INTERNATIONAL CODE COUNCIL

2009/2010 CODE DEVELOPMENT CYCLE

PROPOSED CHANGES TO THE 2009 EDITIONS OF THE

October 24 2009 – November 11, 2009

FIGURE A3-8A - TYPICAL FLOOR TO CRIPPLE WALL CONNECTION (FLOOR JOISTS NOT PARALLEL TO FOUNDATIONS)

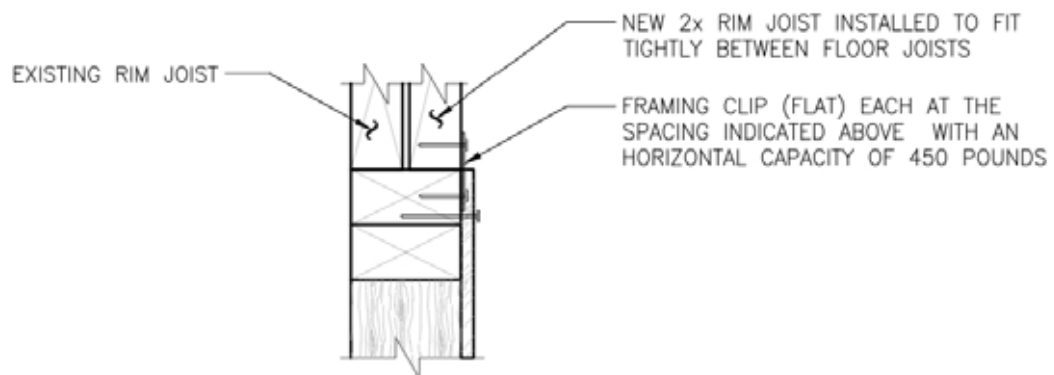
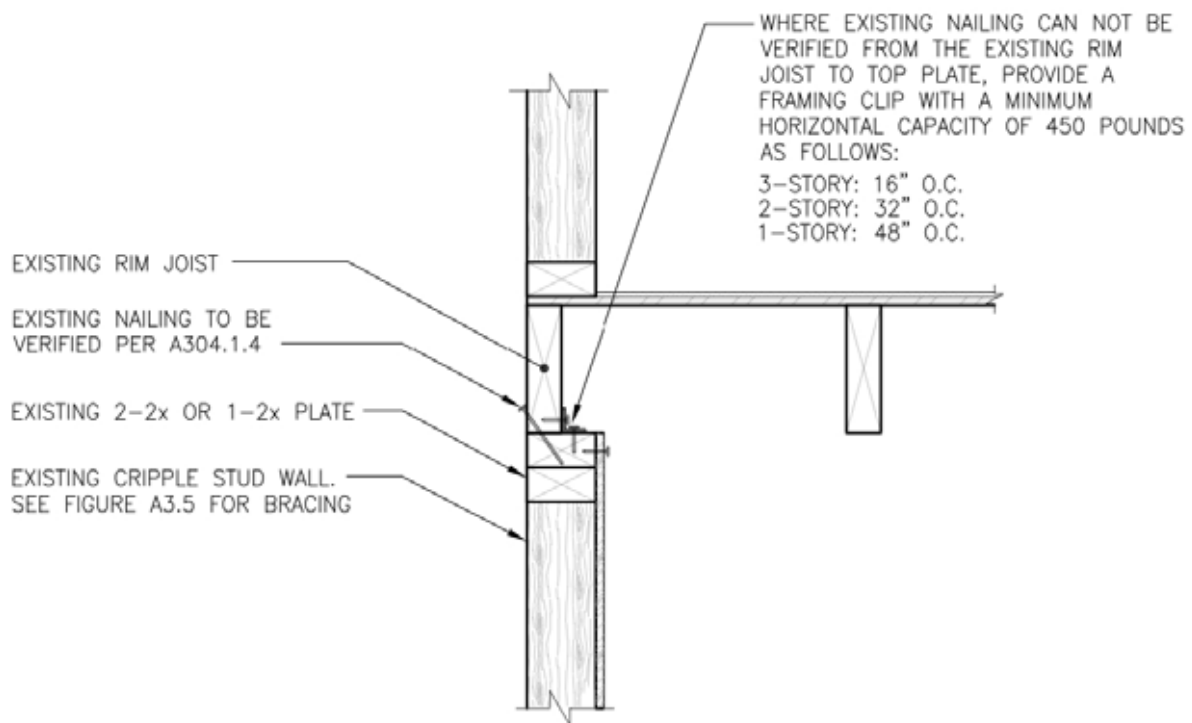
The proposed figures illustrate preferred approaches for creating a load path between the existing floor structure and either the top of the cripple wall (Figures A3-8A and A3-8B) or the sill plate (Figure A3-8C). These new Figures systematically address the four most common conditions found in houses eligible for Chapter A3 with reliable and cost effective details. Similar to portions of 2009 Figure A3-8, these new details utilize readily available and well-documented metal fasteners.

FIGURE A3-1 - NEW REINFORCED CONCRETE FOUNDATION SYSTEM

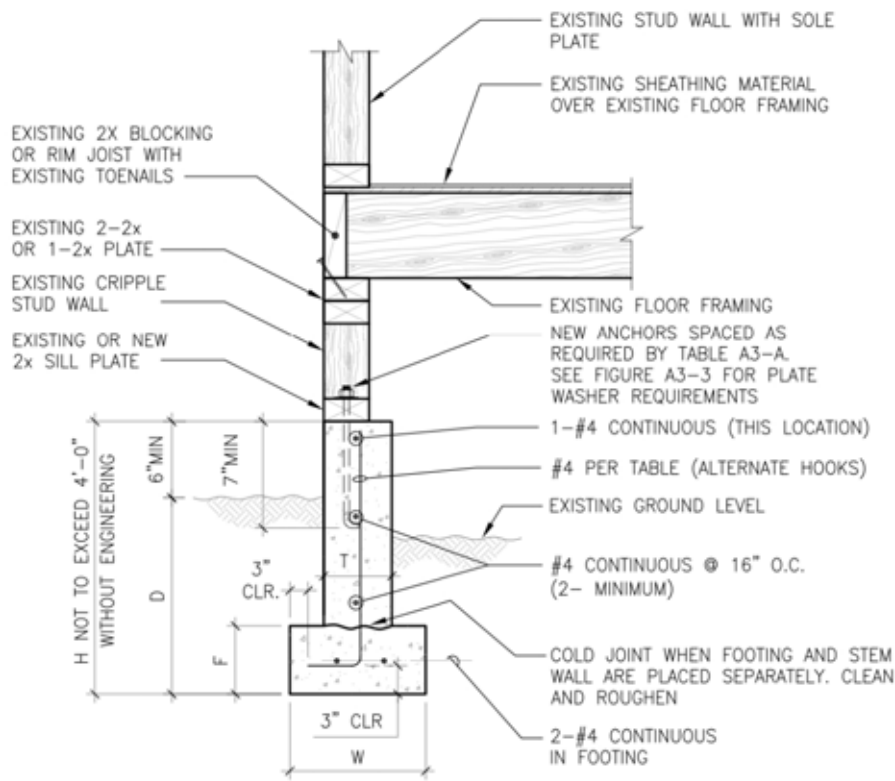
Proposed revision to Figure A3-1 does the following:

- Deletes nails shown at floor sill plate, as they are not required and do not apply to any work required by the sections that reference this Figure, A304.2.3 and A304.3.3.

FIGURE A3-2 – NEW CONCRETE MASONRY FOUNDATION

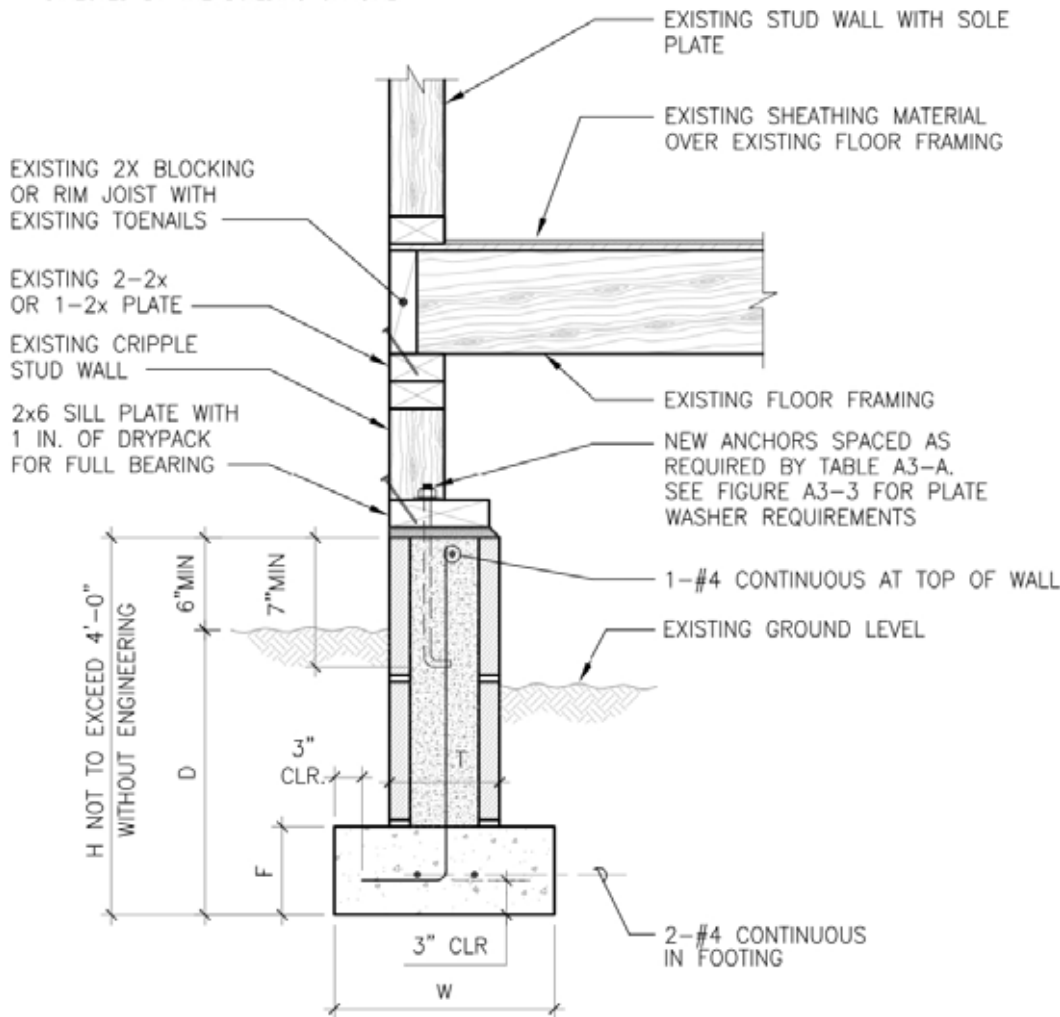
Proposed revision to Figure A3-2 does the following:

- Deletes nails shown at floor sill plate, as they are not required and do not apply to any work required by the sections that reference this Figure, A304.2.3 and A304.3.3.
- Corrects typo. Sill plate call-out should read "2x6".
- Corrects graphical inconsistency for depth of embedment and height above grade.
- Requires 2 #4 continuous bar for the lower footing section in lieu of 1-#4 continuous. This is standard practice and is more appropriate especially when footing is 18" wide.
- Other editorial clarifications, including consistent terminology for "code official," "floor framing," "sill plate," "sole plate" (the horizontal plate above the floor line), and "anchors".

FIGURE A3-3 - SILL PLATE BOLTING TO EXISTING FOUNDATION

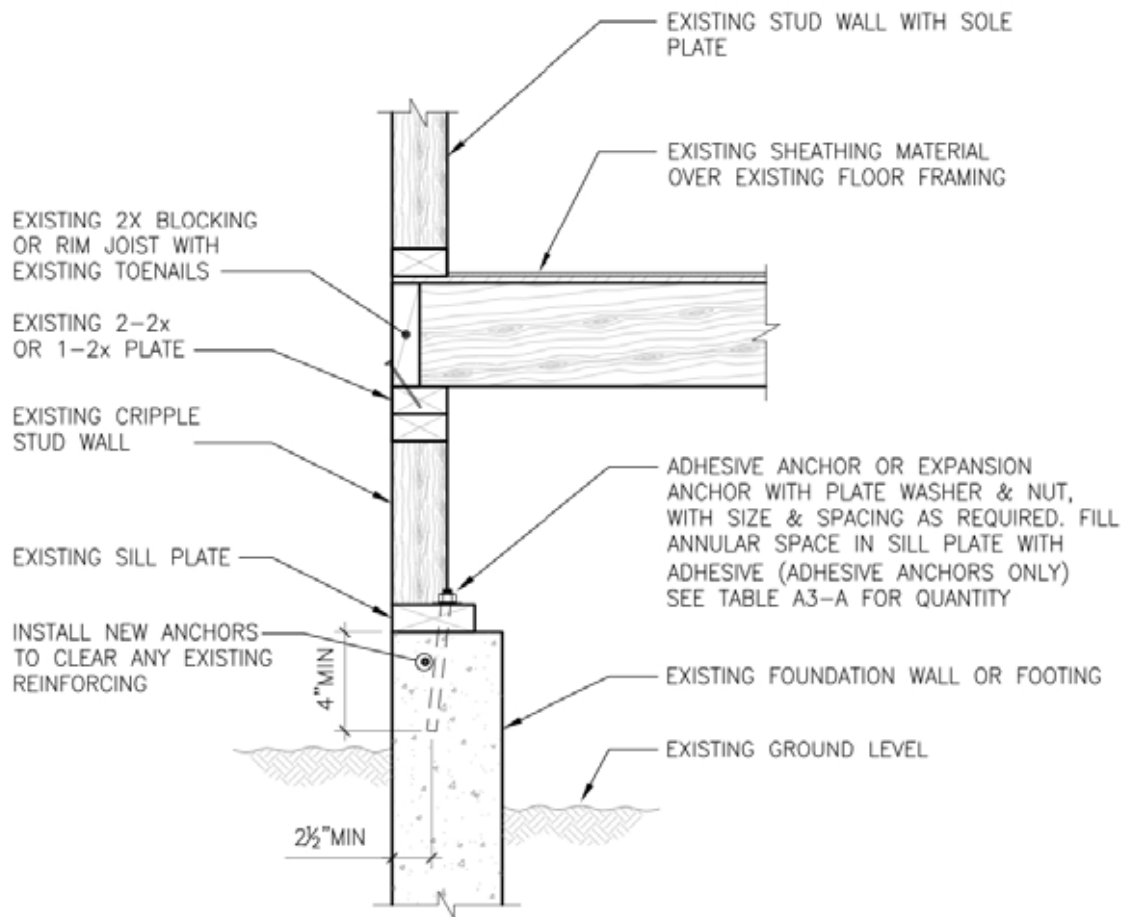
Proposed revision to Figure A3-3 does the following:

- Deletes nails shown at floor sill plate, as they are not required and do not apply to any work required by the section that references this Figure, A304.3.1.
- Clarifies that filling oversized holes with adhesive is required only for adhesive anchors, not expansion anchors.
- Changes washer requirement and size to match current code requirements.
- Requires that new anchors be installed clear of existing reinforcing.
- Other editorial clarifications, including consistent terminology for "floor framing," "sill plate," "sole plate" (the horizontal plate above the floor line), and "anchors".

FIGURE A3-4A - ALTERNATE SILL PLATE BOLTING IN EXISTING FOUNDATION WITHOUT CRIPPLE WALLS AND FLOOR FRAMING NOT PARALLEL TO FOUNDATIONS

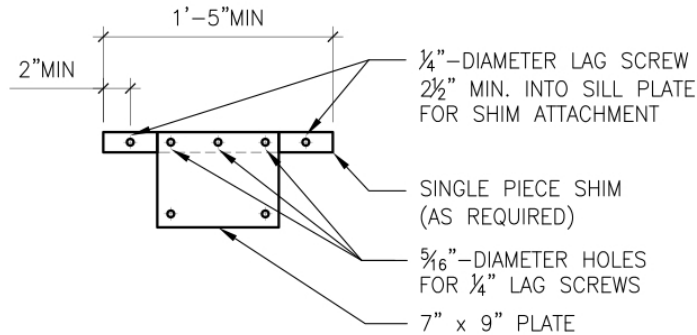
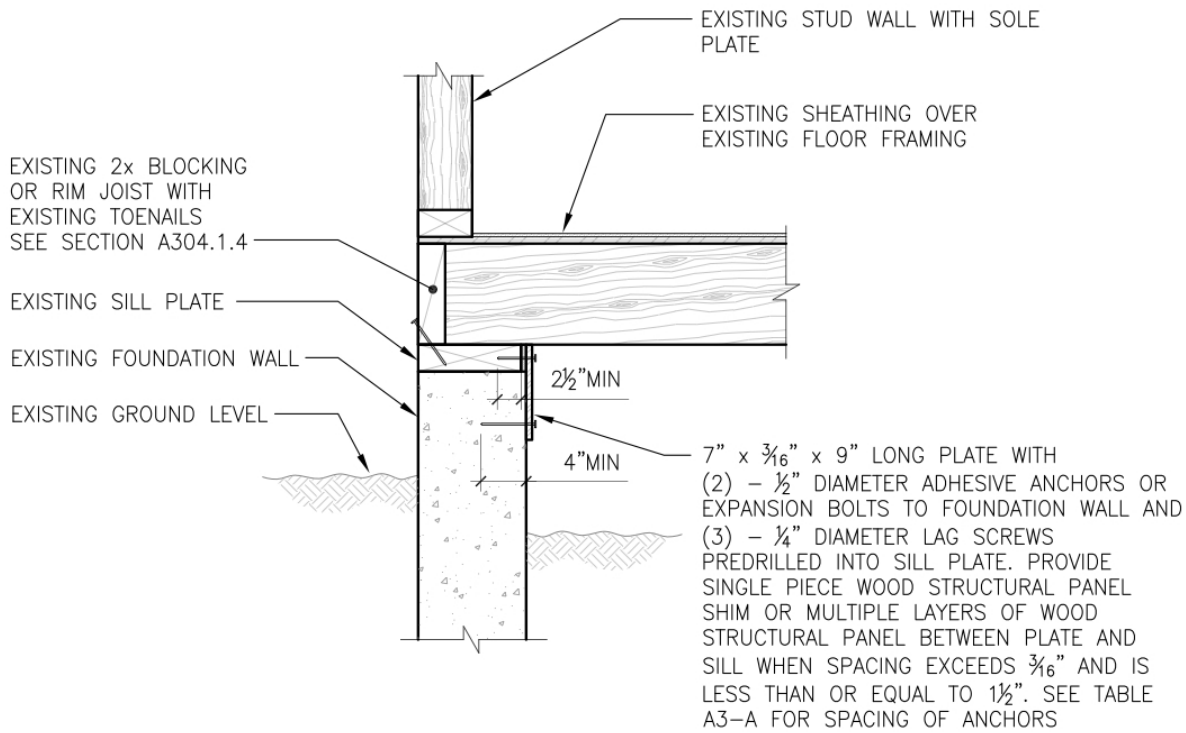
Proposed revision to Figure A3-4A does the following:

- Deletes nails shown at floor sill plate, as they are not required and do not apply to any work required by the section that references this Figure, A304.3.1.
- Adds notes regarding shims. Typical hardware (Simpson, for example) limits shim thickness to 1-1/2".
- Revises plate detail to indicate that 1/4" screws are used from the shim to the sill. Extends the leader from the 5/16" diameter holes to the center-top hole in the metal plate. Changes reference to "lag screws" in the 5/16" call out to "lag holes" since the upper in the metal plate must be 5/16" to accept a 1/4" lag screw
- Adds note to isolate wood shim from the foundation with moisture barrier.
- Revises title.
- Other editorial clarifications, including consistent terminology for "floor framing," "sill plate," "sole plate" (the horizontal plate above the floor line), and "anchors".

FIGURE A3-4B - ALTERNATE SILL PLATE ANCHOR TO EXISTING FOUNDATION WITHOUT CRIPPLE WALL AND FLOOR FRAMING PARALLEL TO FOUNDATIONS

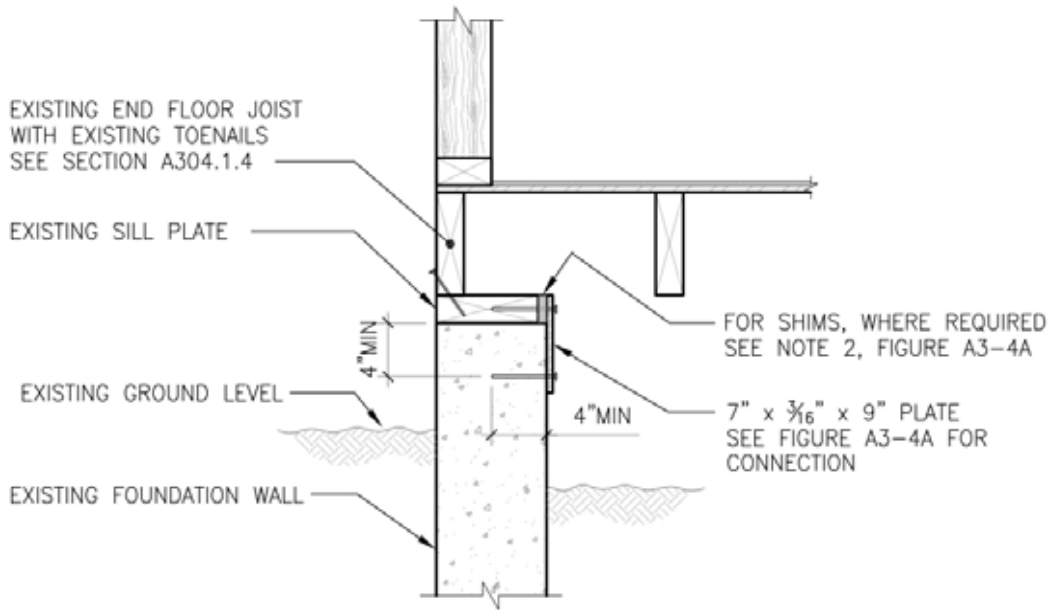
Proposed revision to Figure A3-4B does the following:

- Deletes nails shown at floor sill plate, as they are not required and do not apply to any work required by the section that references this Figure.
- References shim requirements on Figure A3-4A.
- Revises title.

FIGURE A3-5 - CRIPPLE WALL BRACING WITH NEW WOOD STRUC PANEL ON EXTERIOR FACE OF CRIPPLE STUDS

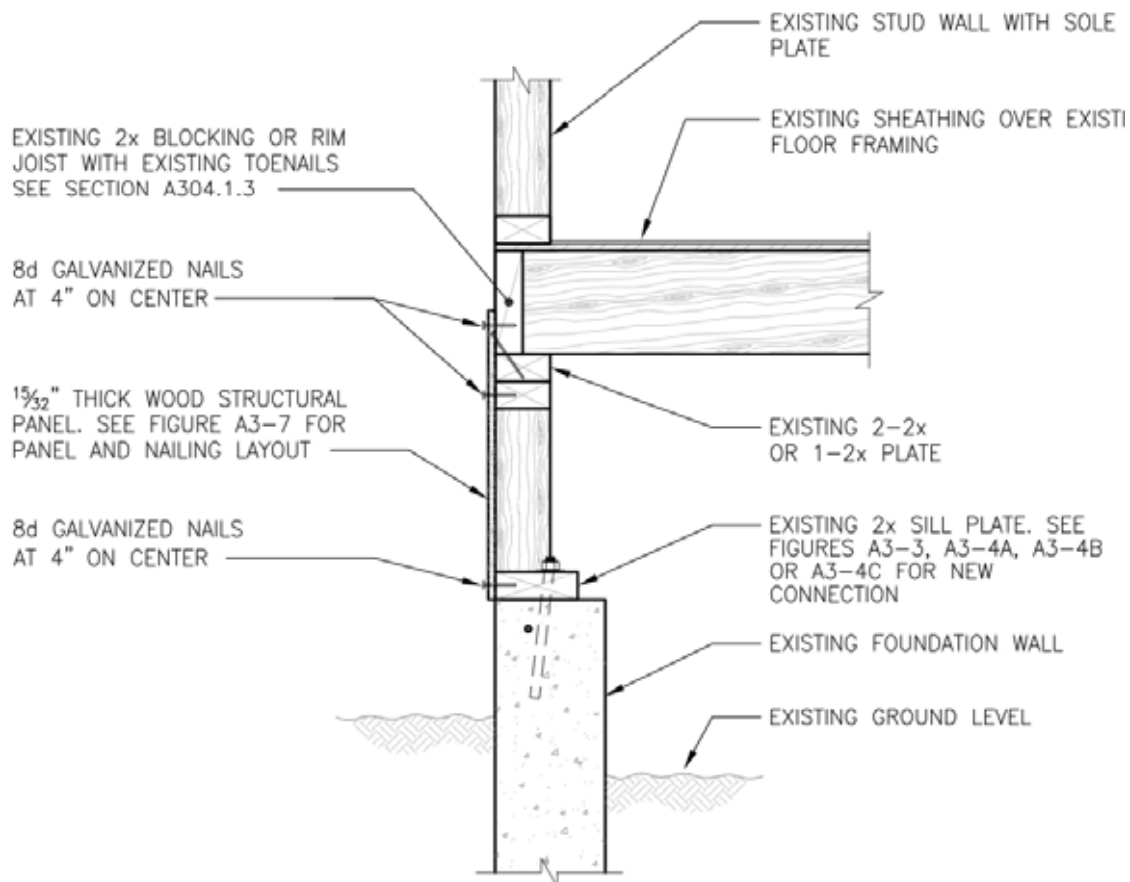
Proposed revision to Figure A3-5 does the following:

FIGURE A3-6 - CRIPPLE WALL BRACING WITH WOOD STRUCTURAL PANEL ON INTERIOR FACE OF CRIPPLE STUDS

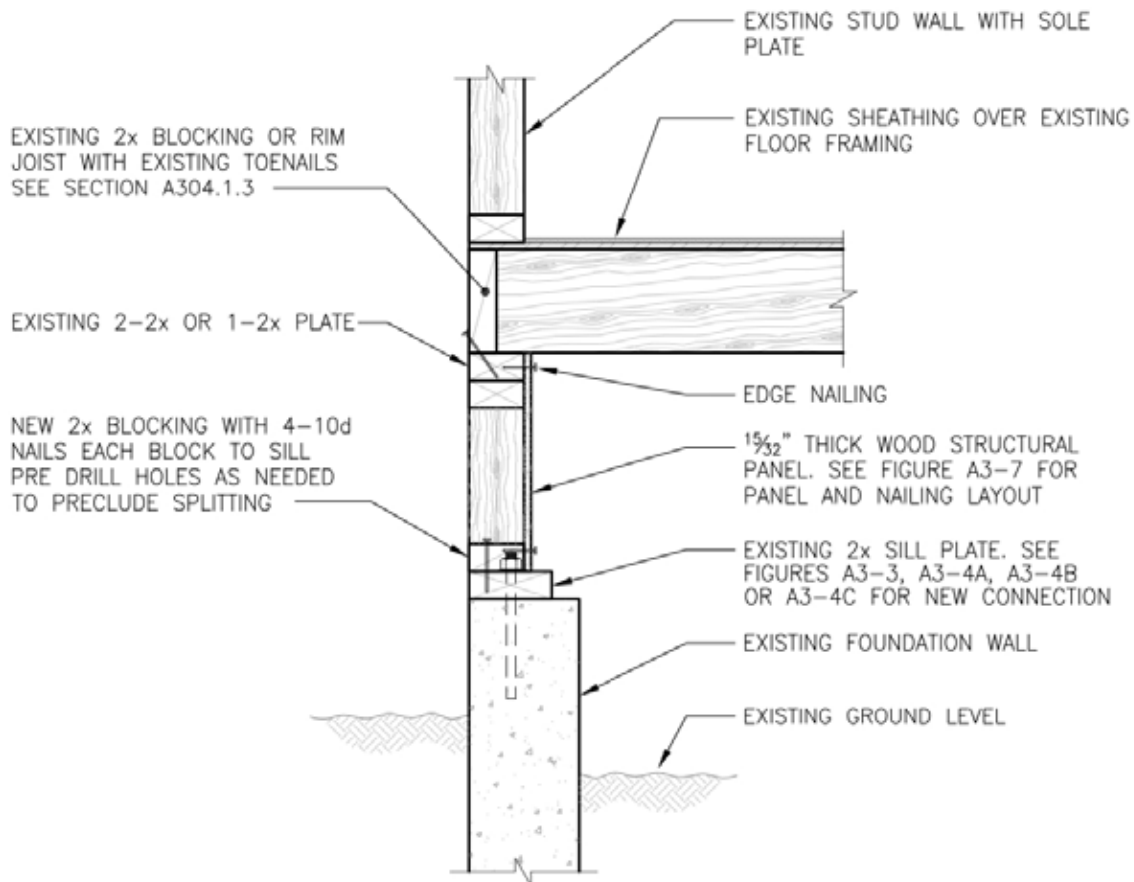
Proposed revision to Figure A3-6 does the following:

FIGURE A3-7 - PARTIAL CRIPPLE STUD WALL ELEVATION

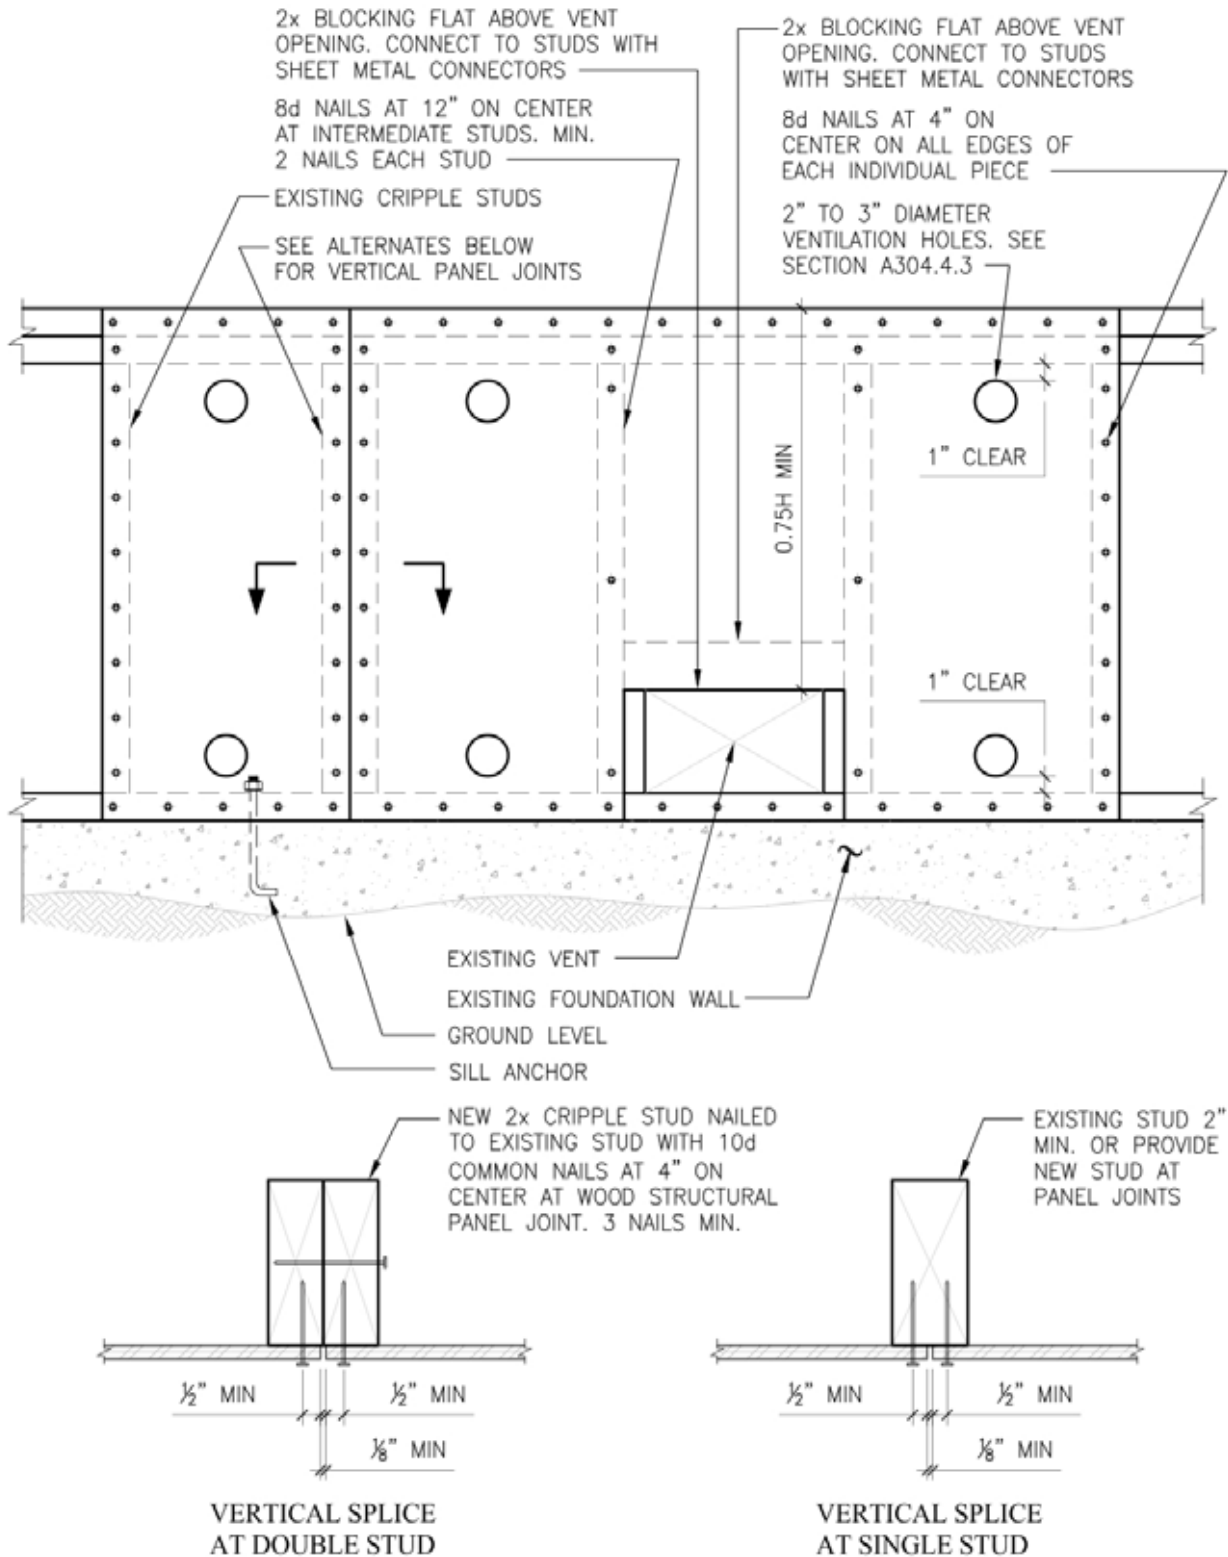
Proposed revision to Figure A3-7 does the following:
